DEVIATION REQUEST AND DECISION FORM

PROJECT INFORMATION – NEW LOG ROAD DEVIATION REQUEST

Project Name : Ellicott Town Center Filing No. 1

HORZ. SCALE: 1"=5'
VERT. SCALE: AS SHOWN
SURVEYED: CHECKED:
CREATED: 5/5/05 LAST MODIFIED: 9/12/19
PROJECT NO: 090001 MODIFIED BY: BJJ
SHEET: TY1

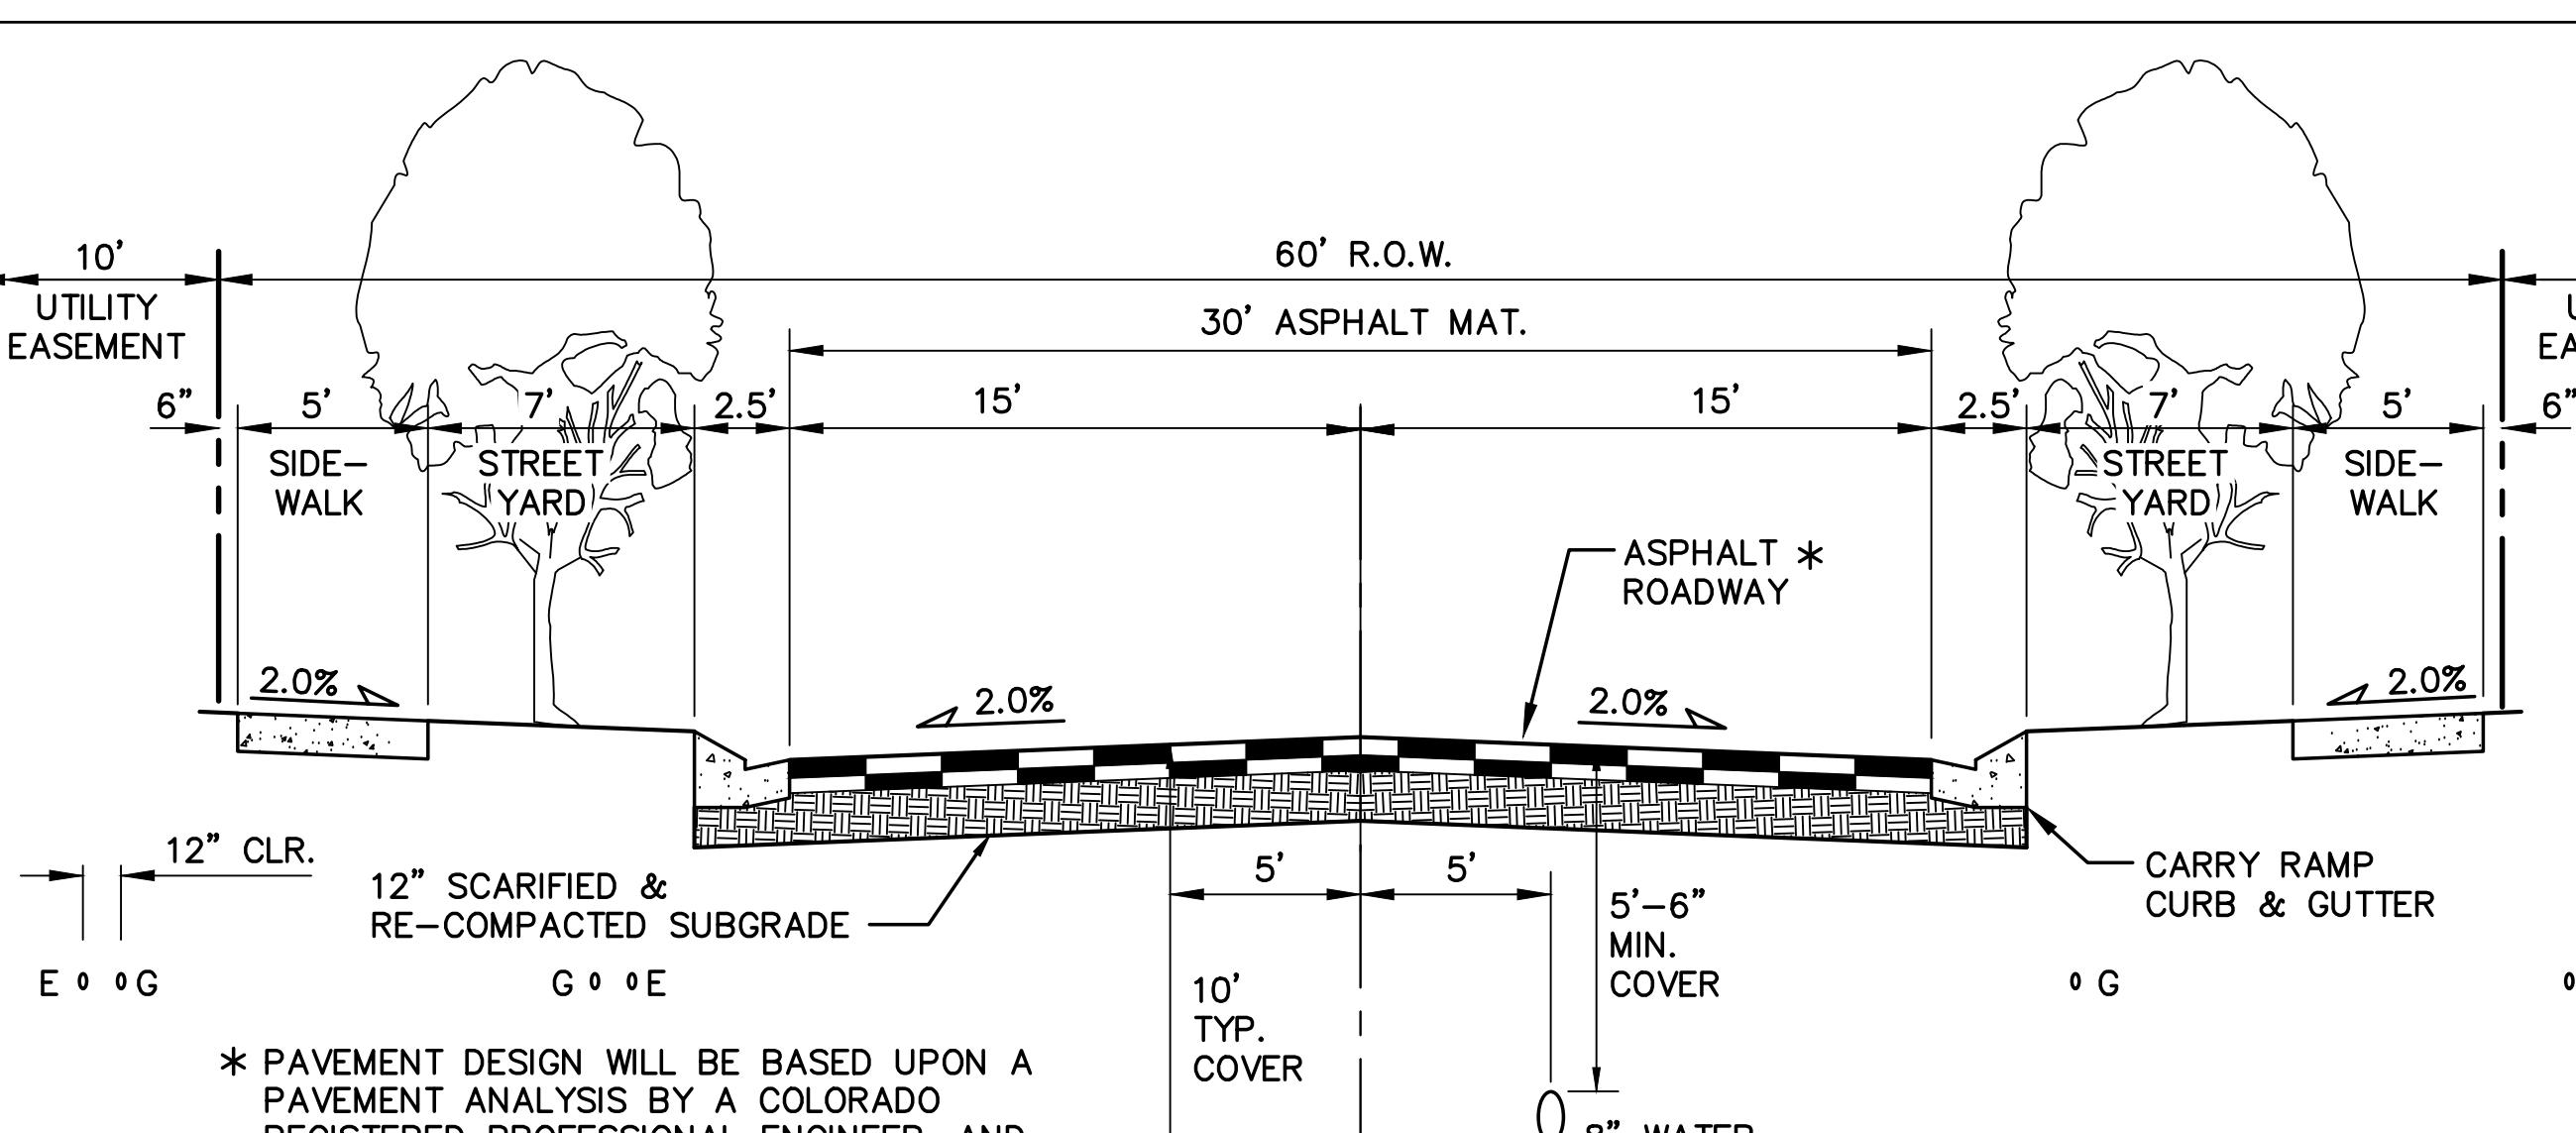
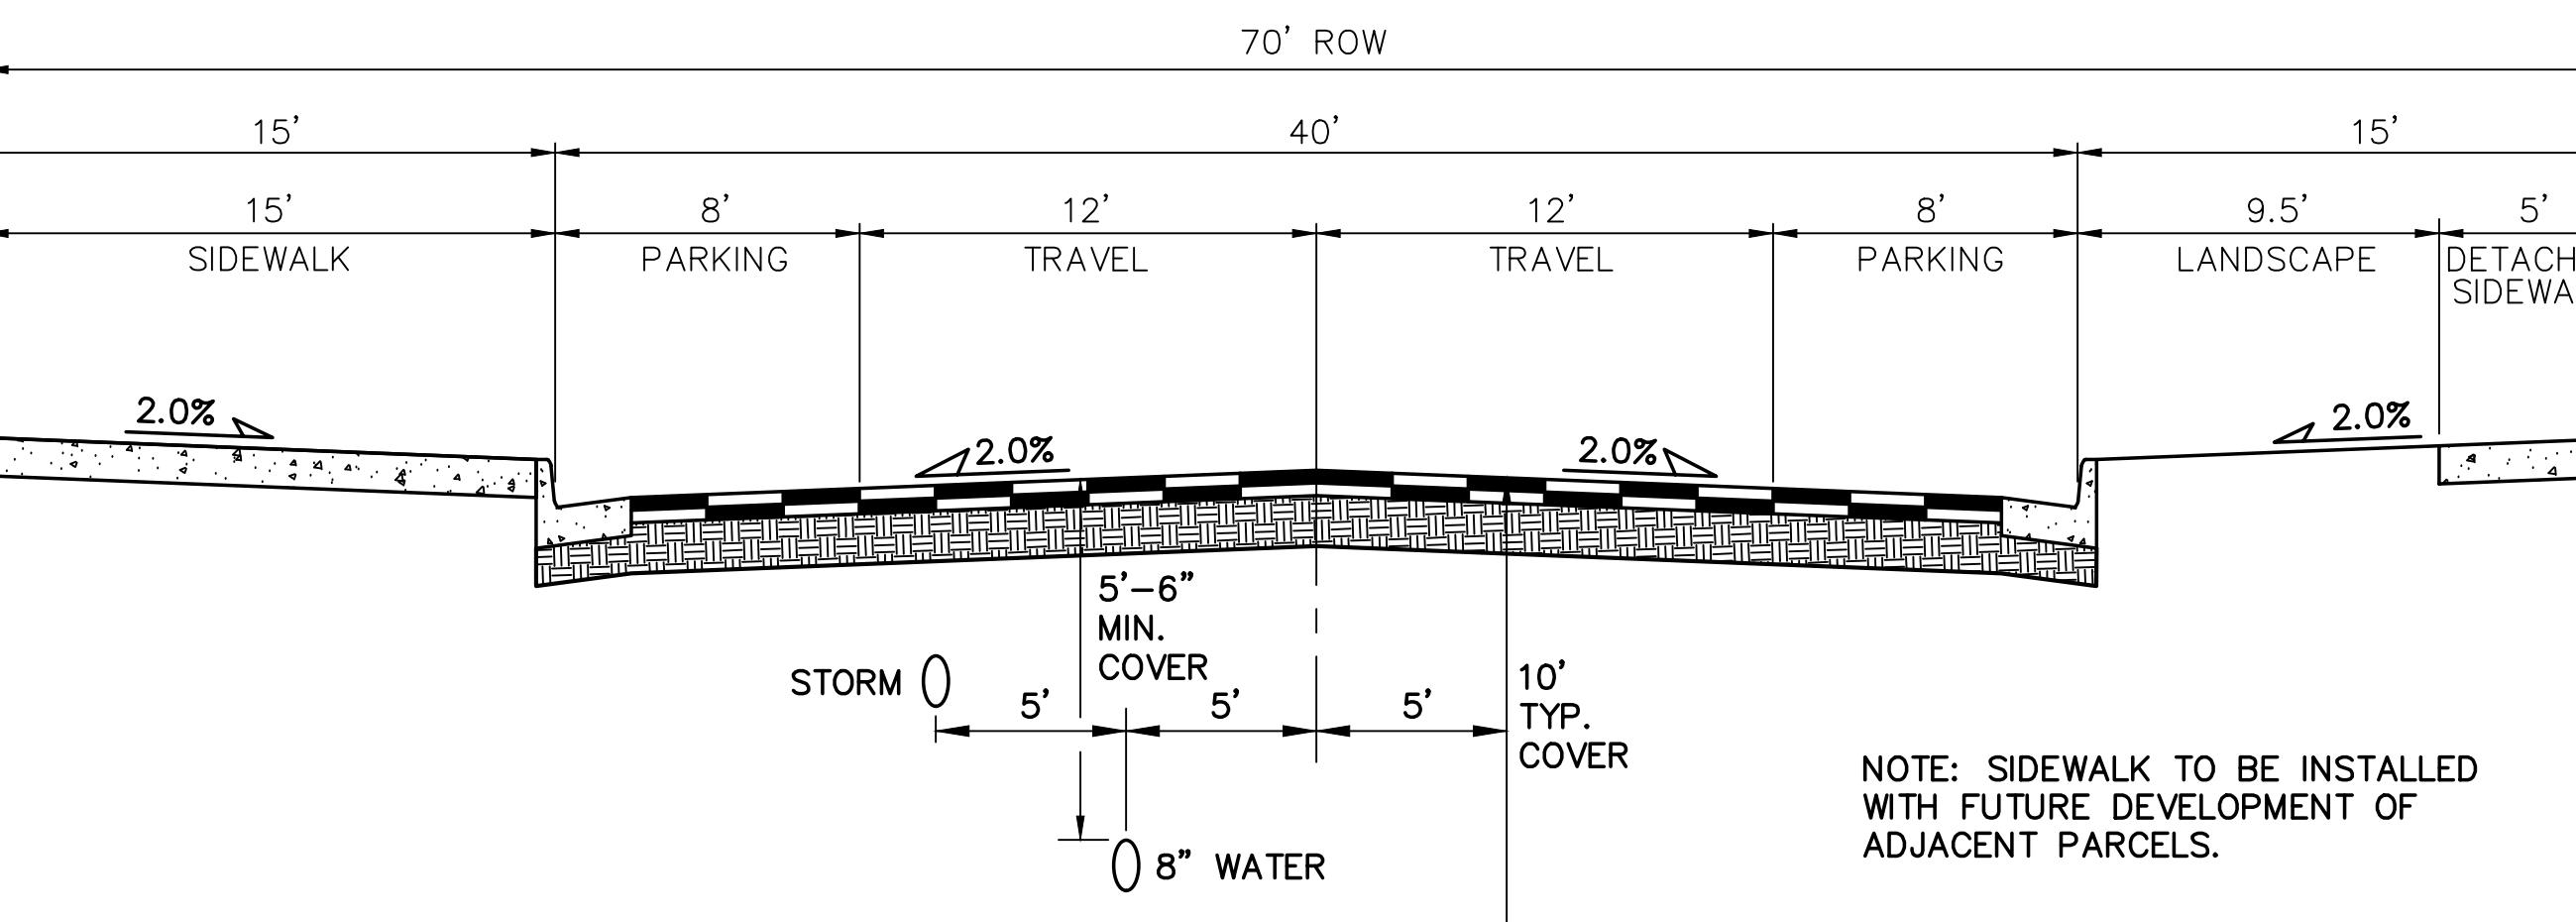
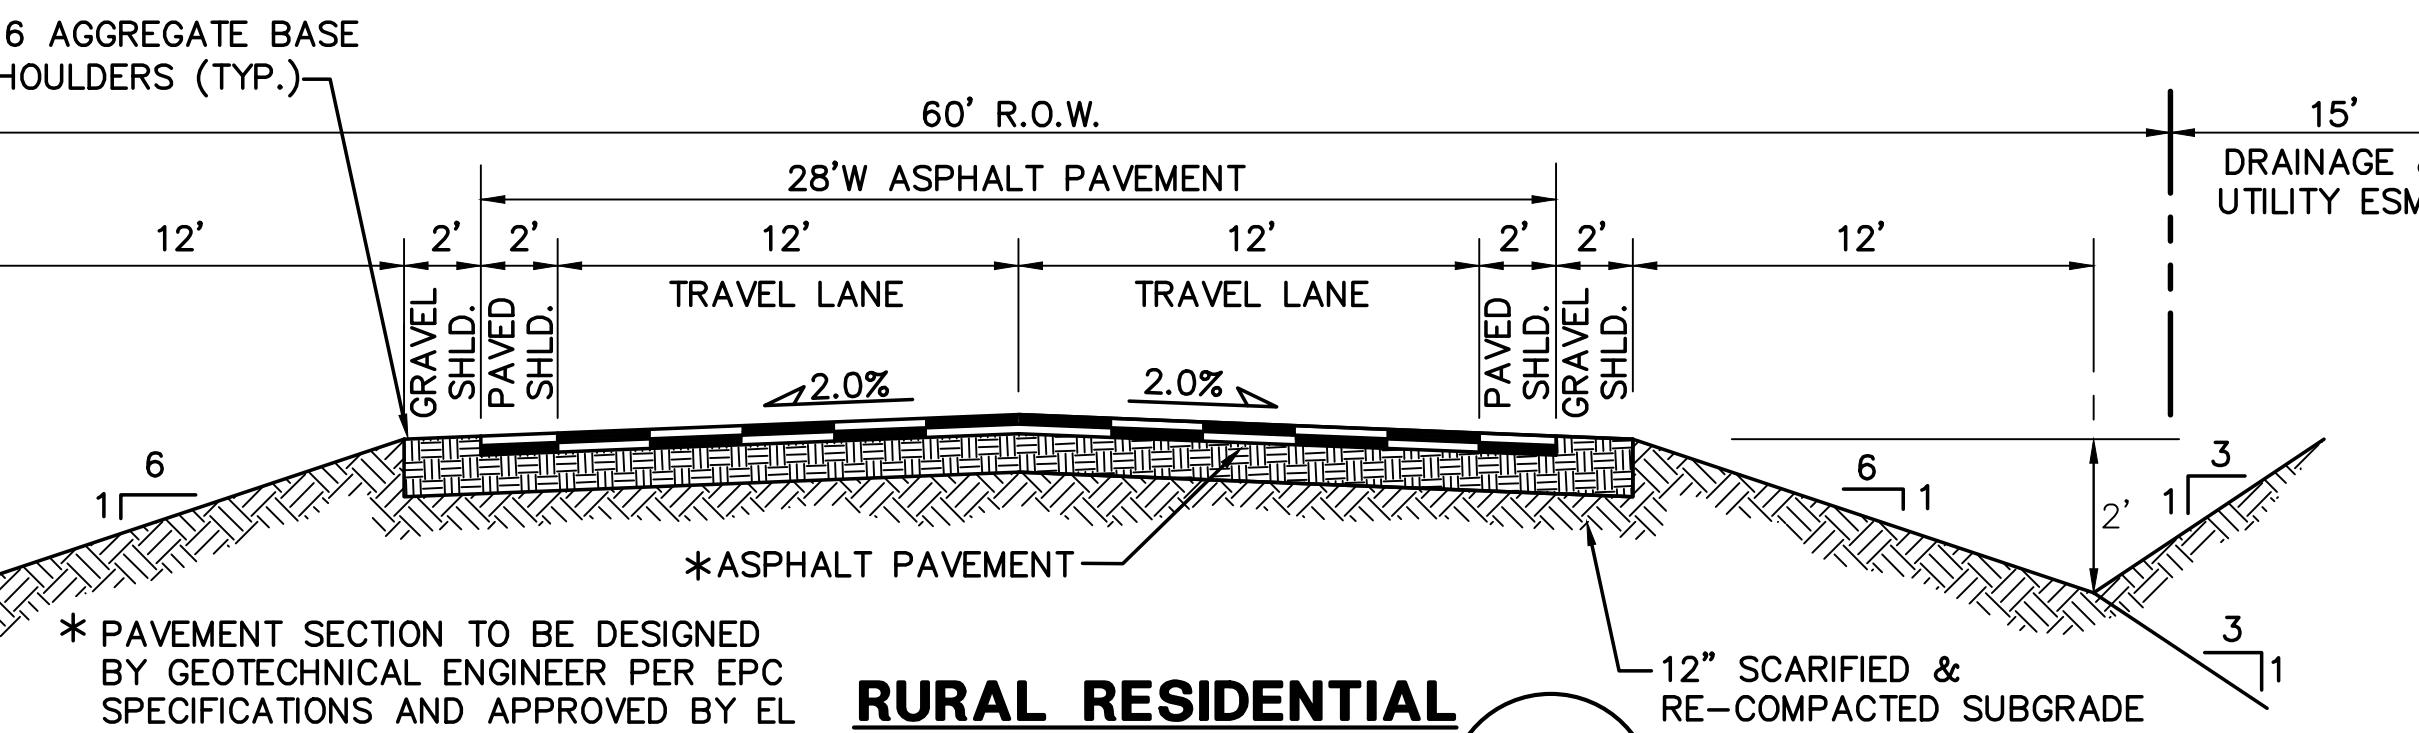
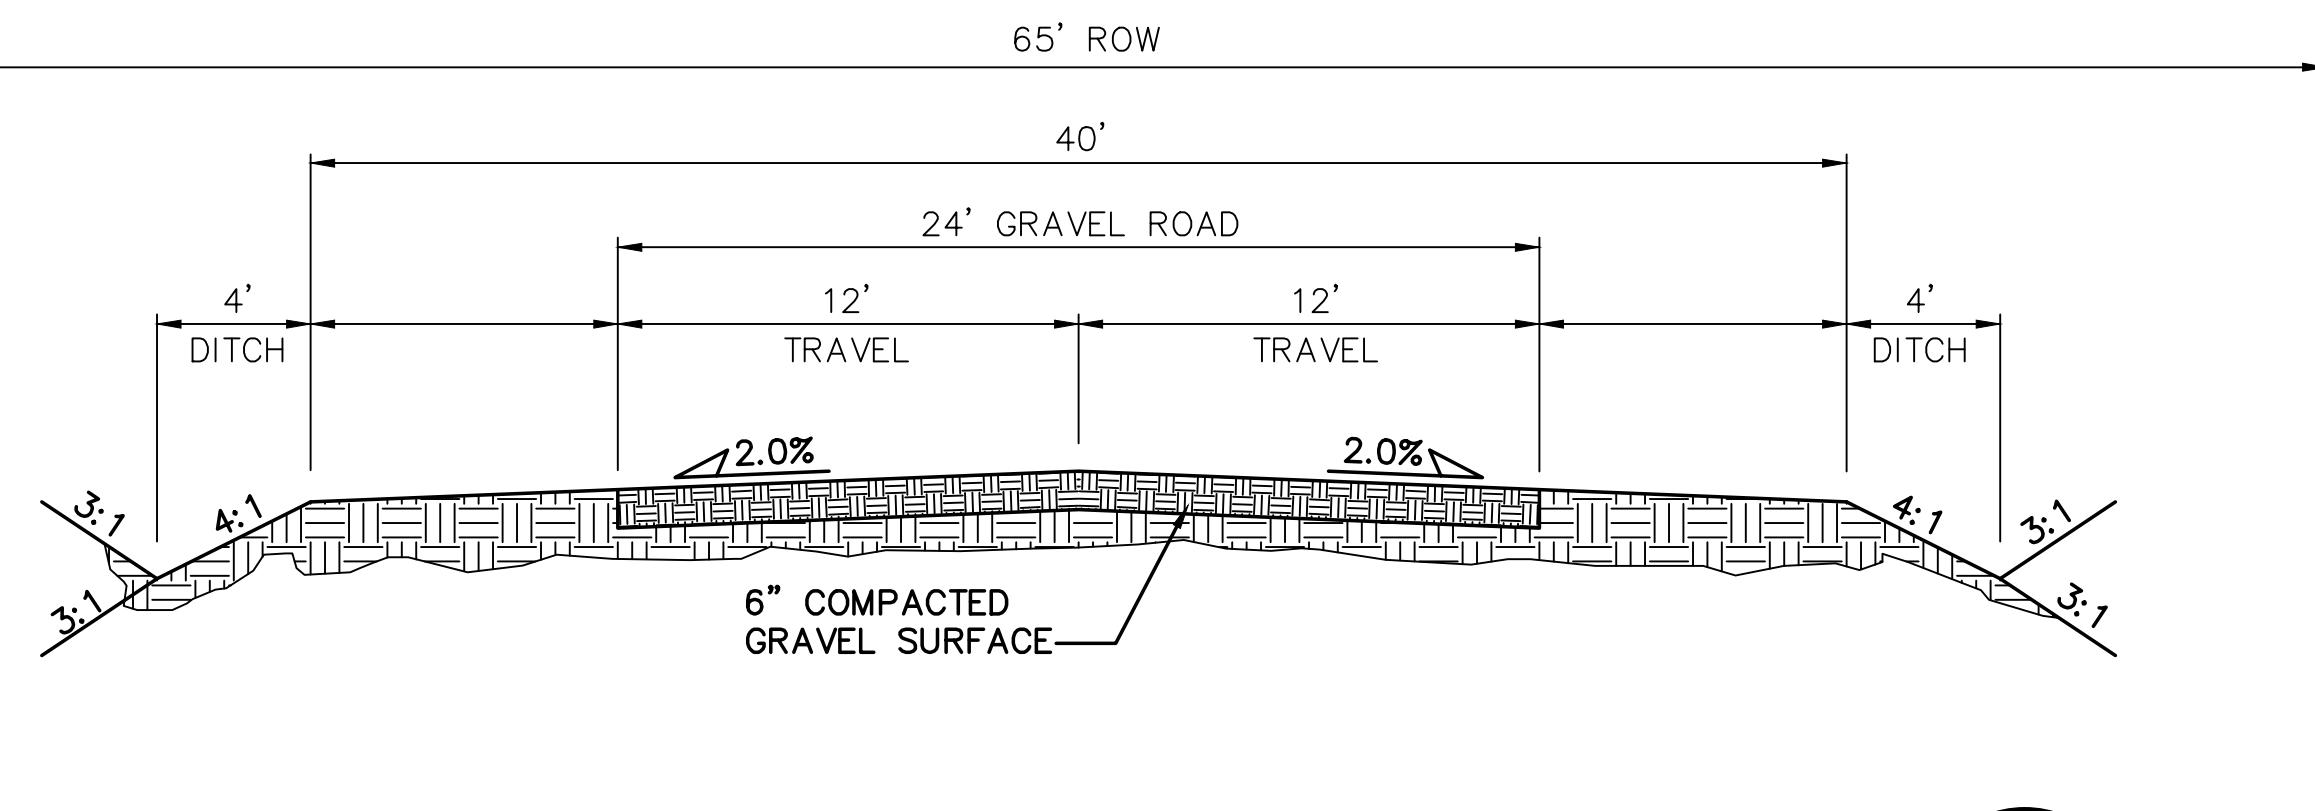
Village Main Street is ultimately classified as an Urban Non-Residential Collector through the Town Center area, and an Urban Residential Collector through the residential areas. The proposed deviations consist of modified cross-section elements including a 36-foot asphalt width for the Non-Residential Collector and a 30-foot asphalt width for the Residential Collector road segments, as well as an interim gravel secondary access road section during the initial phase of development. The proposed deviations are depicted on the Typical Road Section Drawings (Sections A-C, Sh. TY1).

The current ECM standard is a 48-foot asphalt width for an Urban Non-Residential Collector and a 36-foot asphalt width for an Urban Residential Collector. The narrower road widths are consistent with new urbanist land planning as approved in the Ellicott Town Center PUD. Minimum travel lane widths of 12 feet are provided in accordance with current ECM standards.
